PRELIMINARY WASTEWATER MASTER PLAN

PRELIMINARY Basis of Design SCOTTS DALE Report □ ACCEPTED ACCEPTED AS NOTED ☐ REVISE AND RESUBMIT Disclaimer: If accepted; the preliminary approval is granted under submitted for city review and approval (typically during the DR or PP case). The final report shall incorporate further water or sewer design and analysis requirements as defined in the city design standards and policy manual and address those items noted in the preliminary review comments (both separate and included herein). The final report shall be submitted and approved prior to the plan review submission. For questions or clarifications contact the Water Resources Planning and Engineering Department at 480-312-5685. DATE 9/10/2020 BY Idillon **DATE** 8/31/2020

Scottsdale Collective

Entertainment/Canal Districts Scottsdale, AZ 85251

MAYA HOTEL SEWER LINE RELOCATION EXHIBIT

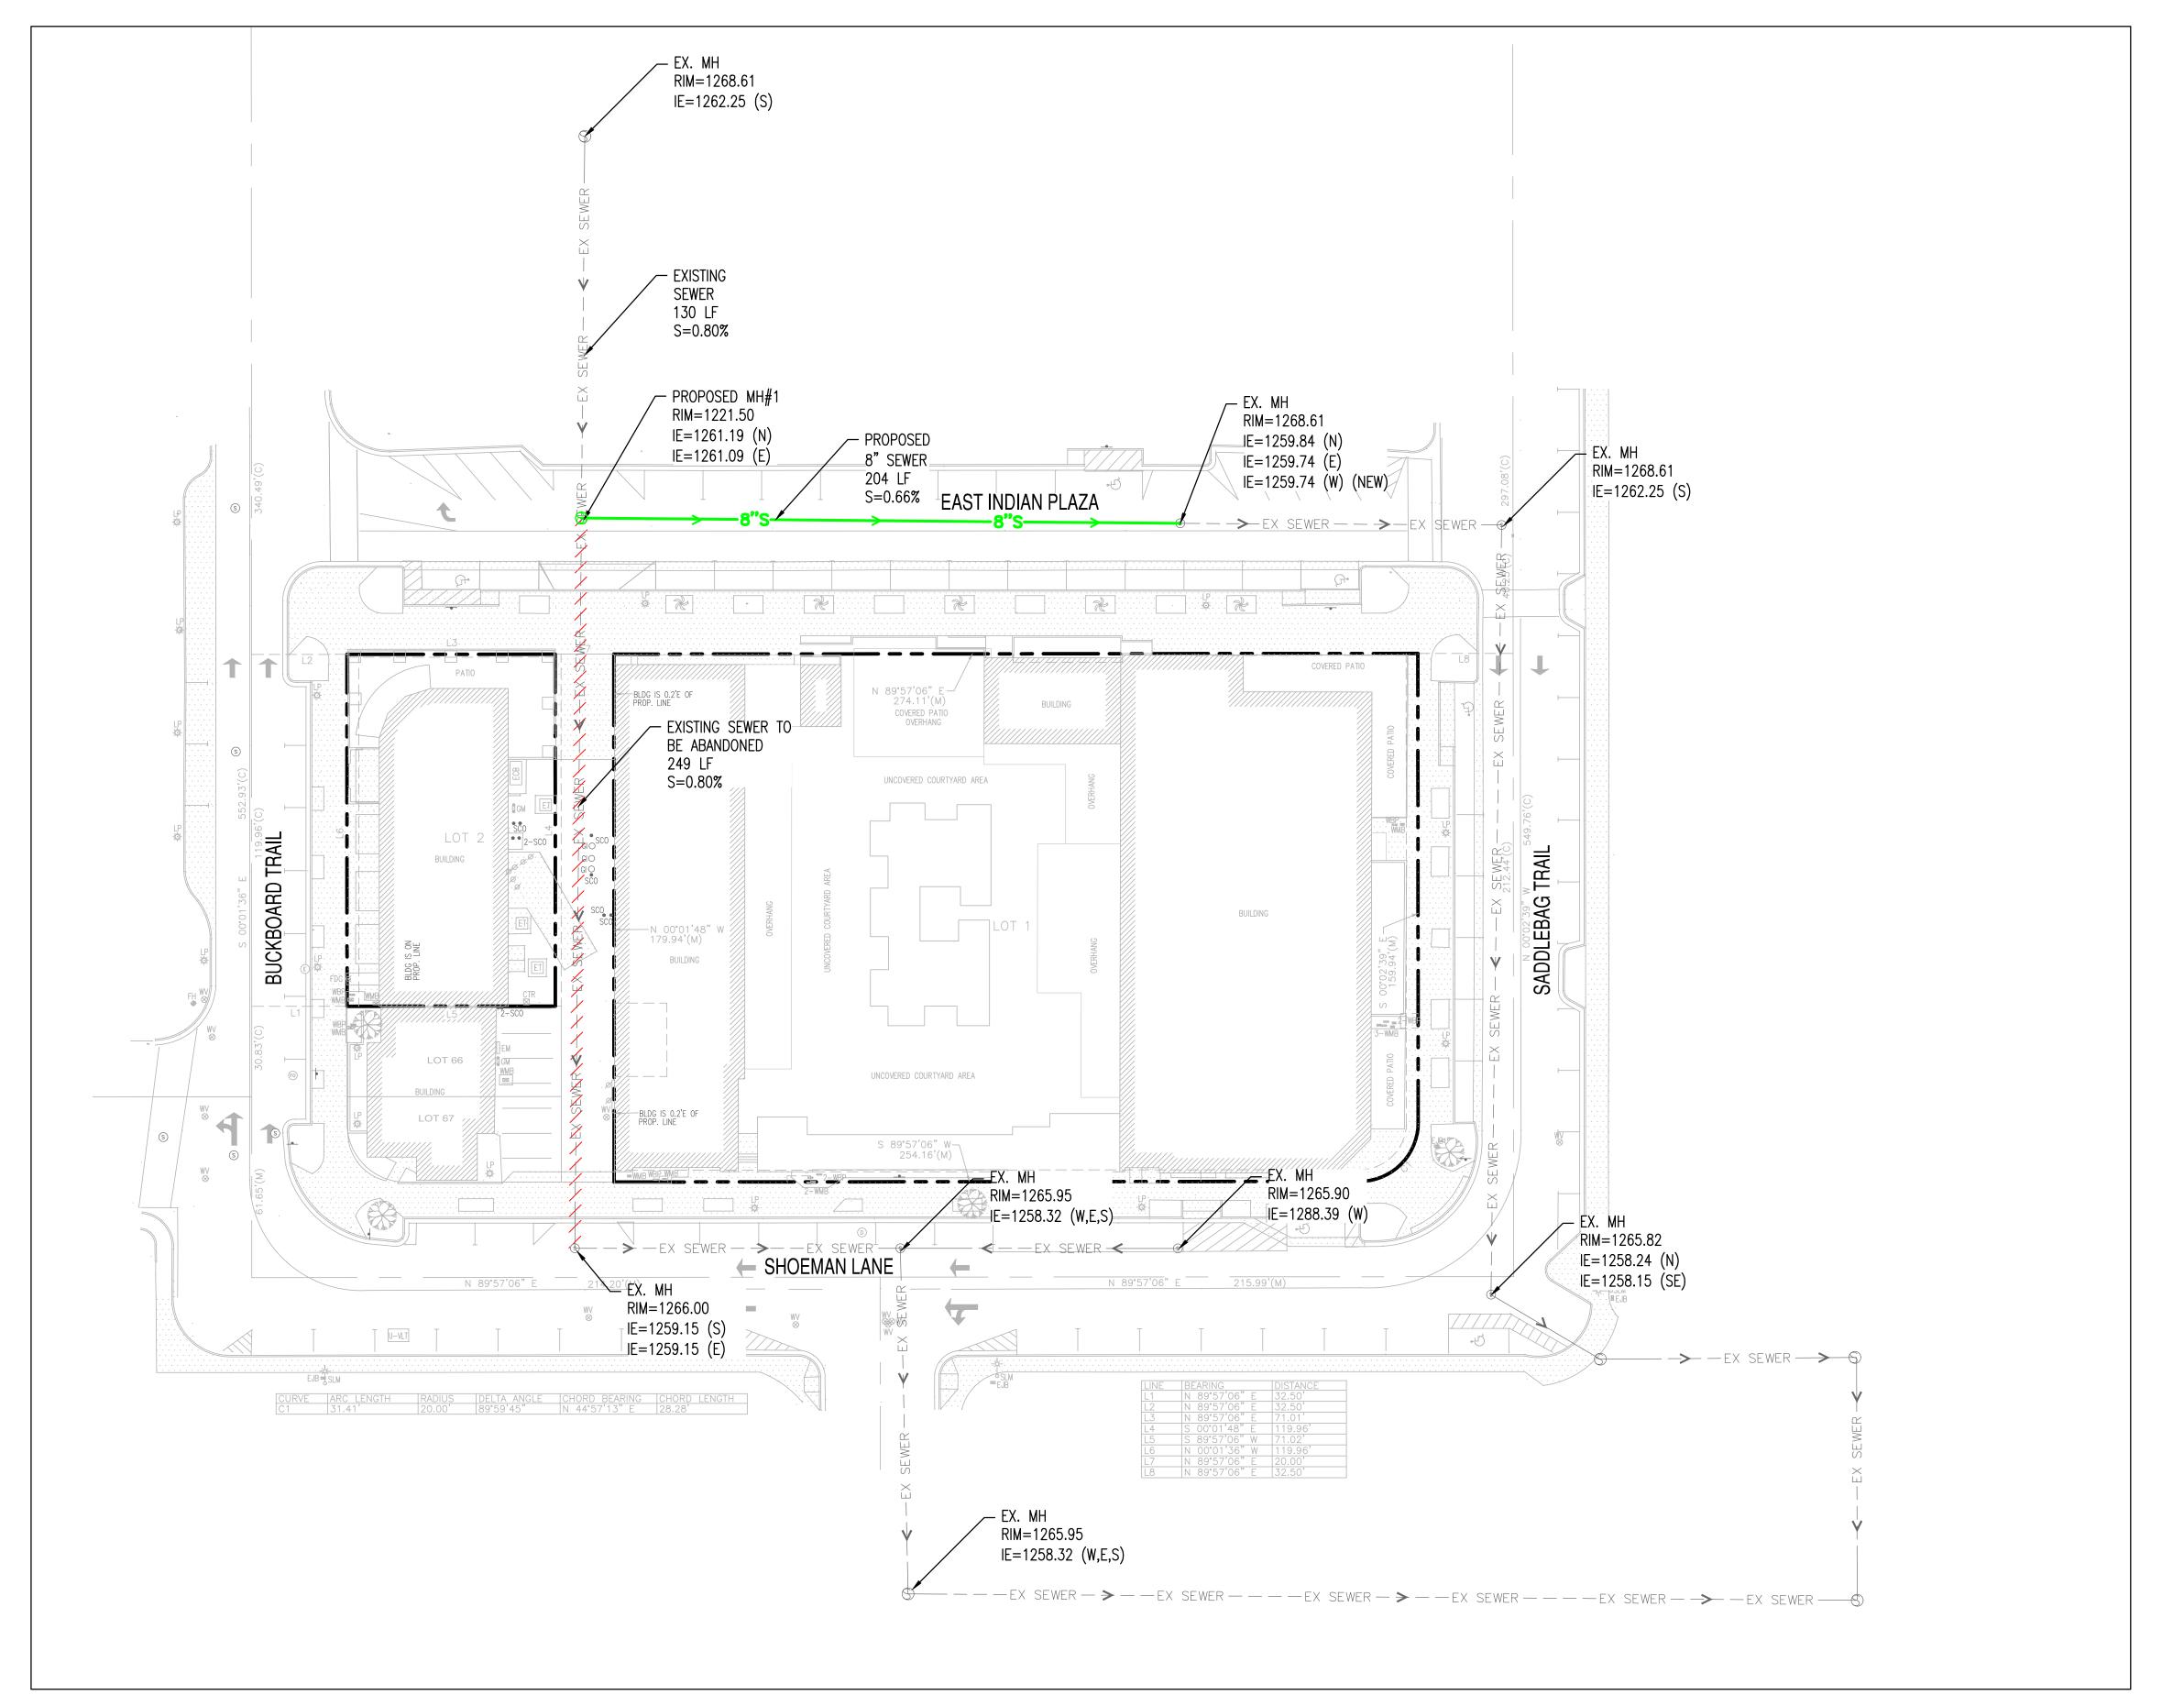
The Maya proposes a connection to the south to the existing collection system within the Entertainment District. The Maya will require a 6" service line at a minimum 0.01 ft/ft and with a proposed alley abandonment will need to relocate an existing 8-inch sewer. Refer to **FIGURE 5** for the proposed sewer relocation.

The Maya proposes to abandon an alley east of the site and will need to reroute an existing 8" sewer. Refer to **FIGURES 5 and 6** for the proposed reroute.

- c. ** STIPULATION: Public sewer to be rerouted for Maya Hotel
 - d. ** STIPULATION: The existing sewer on south side of Camelback shall be removed. A new 12" sewer shall be installed from City Center project to 75th Street.
